Town of Westport
Planning & Zoning
Commission

384 Greens Farms Road
Coastal Site Plan Application

Consistent with the Flood Zone Standards

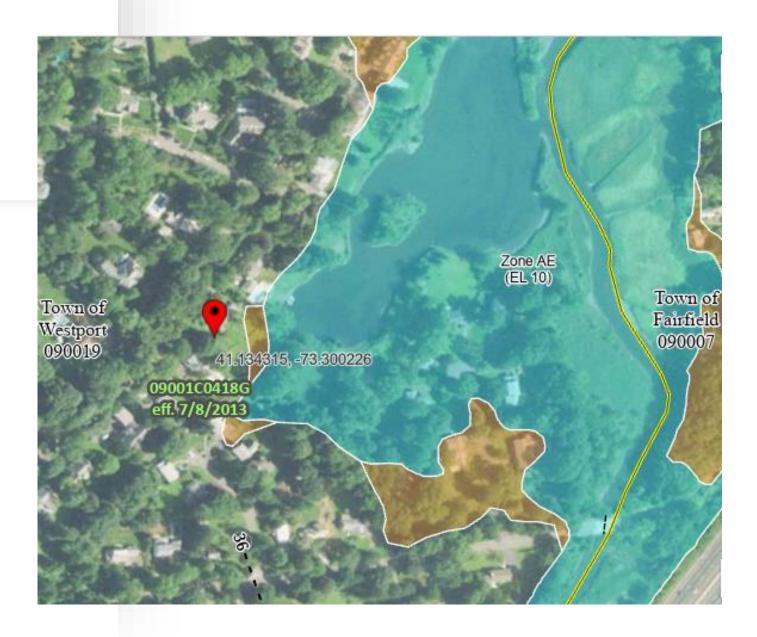
The rear of the property contains both the 100-year (AE 10) and 500- year flood zones.

There are no proposed structures within this hazard.
